METFORD MEDICAL

ARCHITECTURAL DRAWING SCHEDULE

ISSUE FOR DA

REVISION 2 UPDATES (01/12/23)

2 NORTHERN BOUNDARY RETAINING WALL DETAIL 02

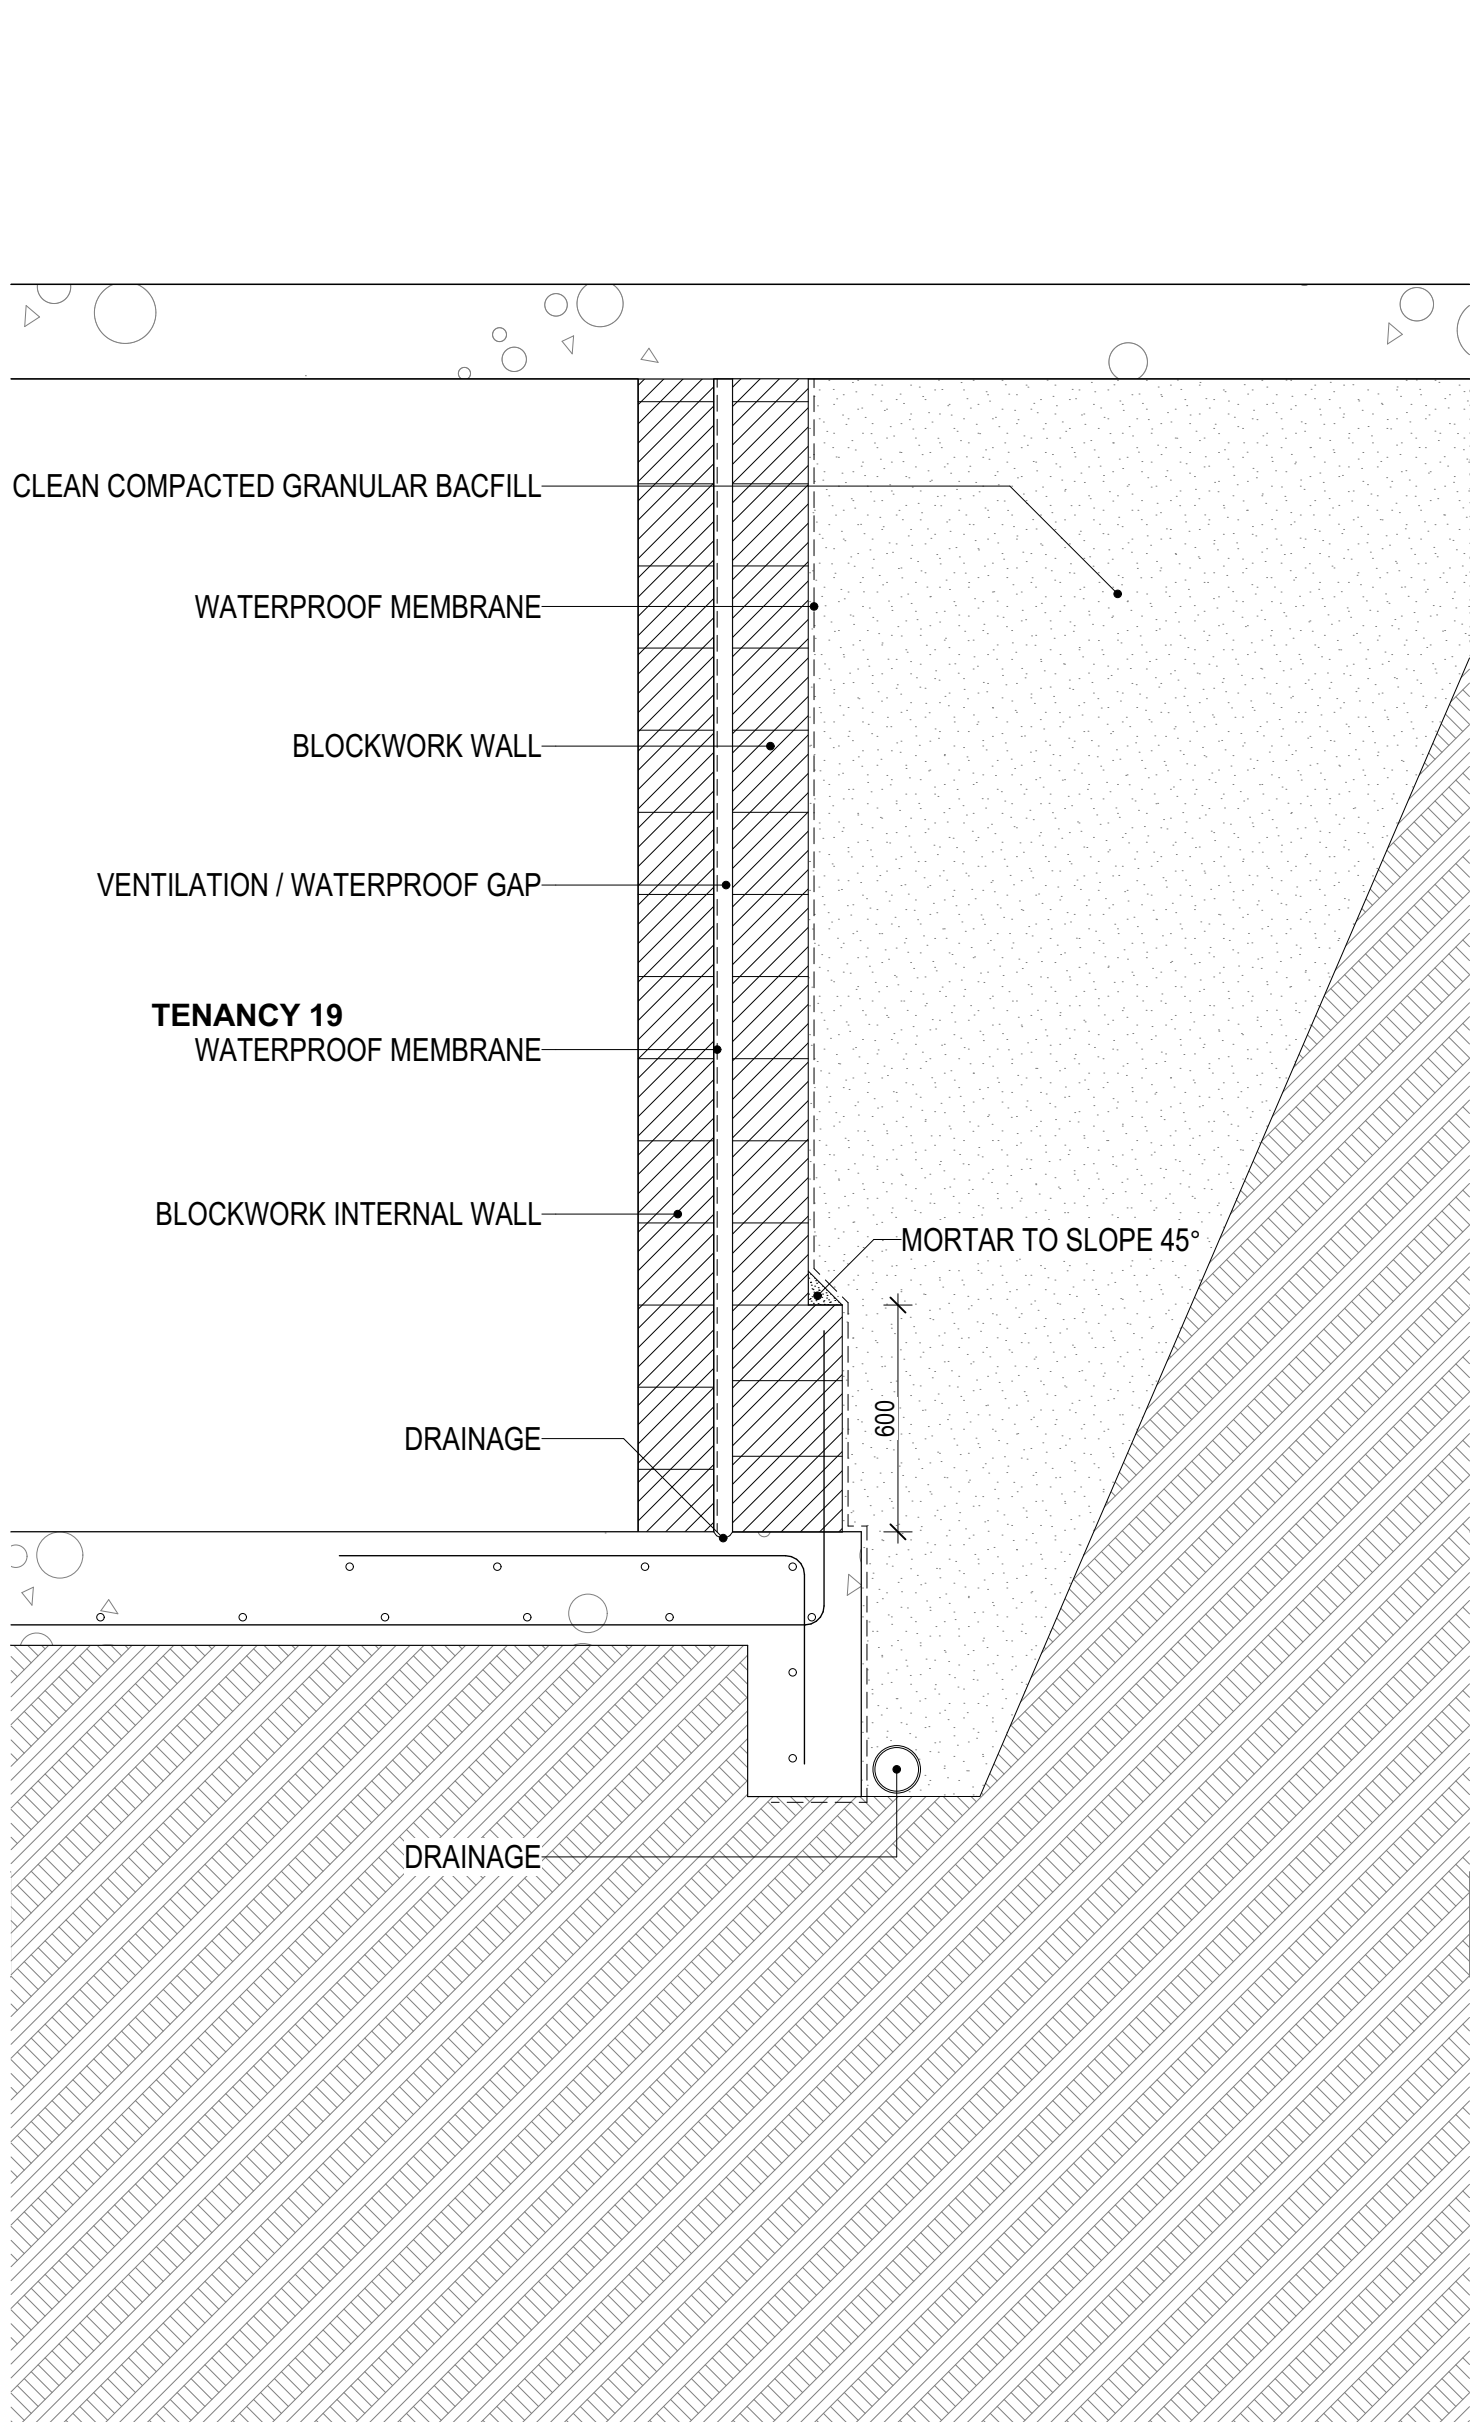
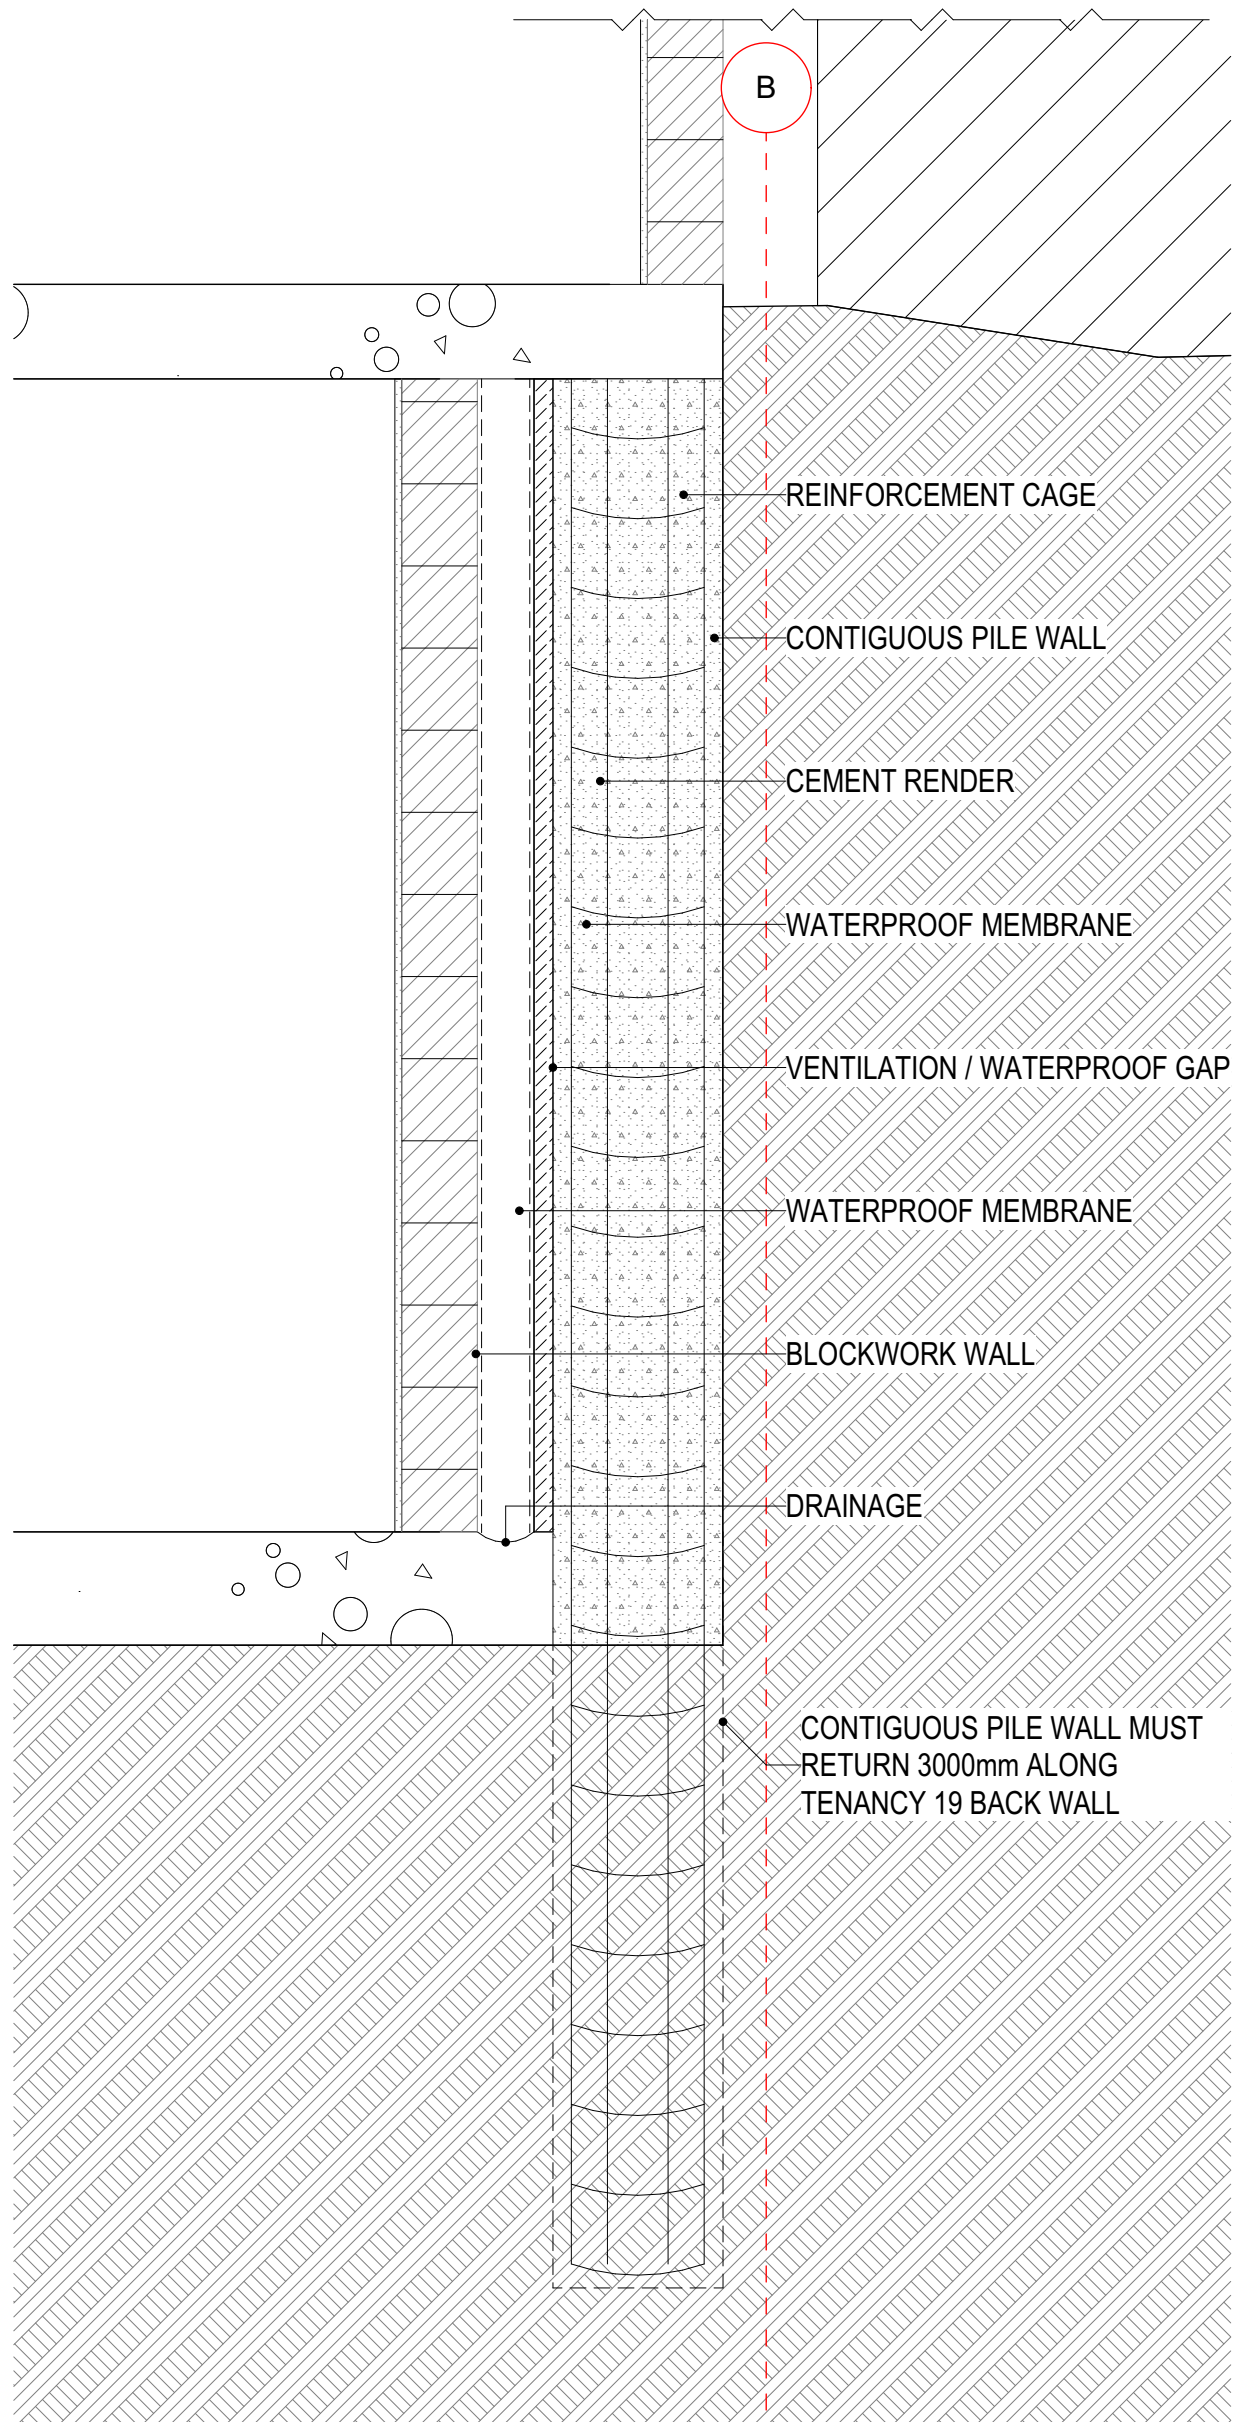
REVISION 2 UPDATES (01/12/23)
- RETAINING WALL DETAILS UPDATED & REFINED
